Subject: DA2024/1409 - 122A Crescent Road Newport - Submission from W. Lorimer - 40 Rednal Street MONA Vale

Re: Development Assessment DA2024/1409 – 122A Crescent Road, Newport
Issues of Concern identified by 40 Rednal Street Mona Vale

Extract Part of Figure 2 -Original and Revised Marina Layout of SEE

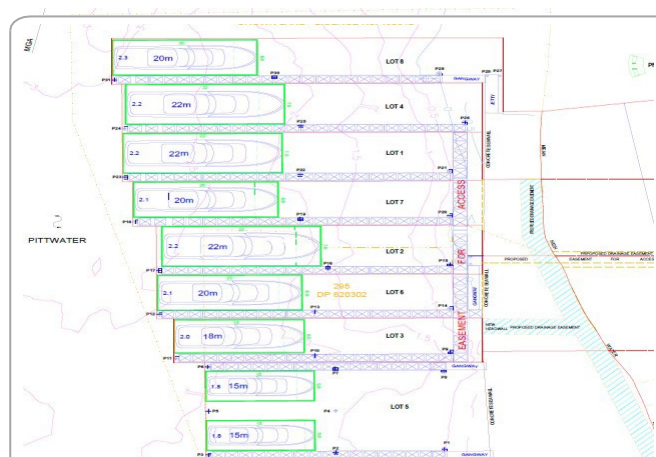
17. Please clarify that Lot 5 has two pontoon fingers and berthing facilities of more than 2 vessels having 15 metre length, Figure 2 Original and revised Marina Layout in the SEE.

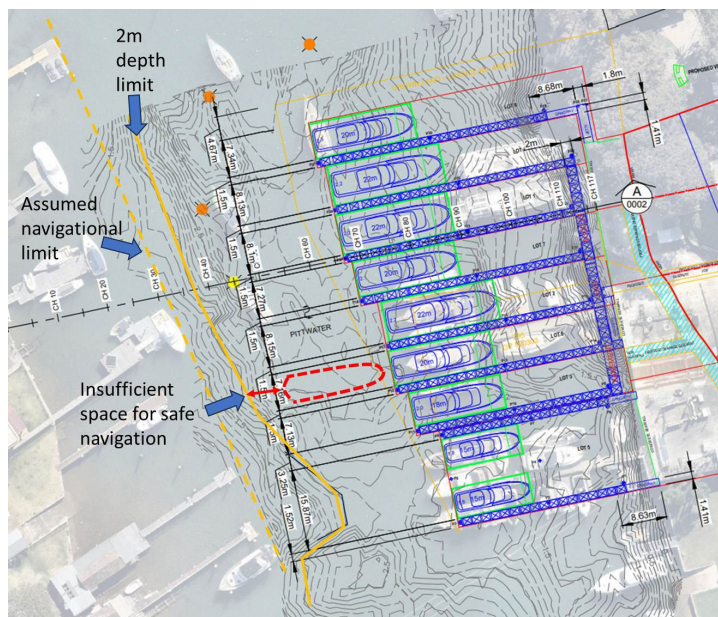
47. Provided here is an Aerial photograph of the site and boundaries Figure 4 of the SEE, where the RED line is the Site Boundary, the BLUE line the Lot Boundary and the dotted yellow line the License Area – Crown Land

53. This aerial photograph clearly depicts the excessive the excessive encroachment in Winji Jimi Bay as well as extending the commercial marina footprint in the order of 50% more towards the northwest.

54. The excessive encroachment is unsafe for waterway traffic, and a major property boundary encroachment effecting the properties along Rednal Street.
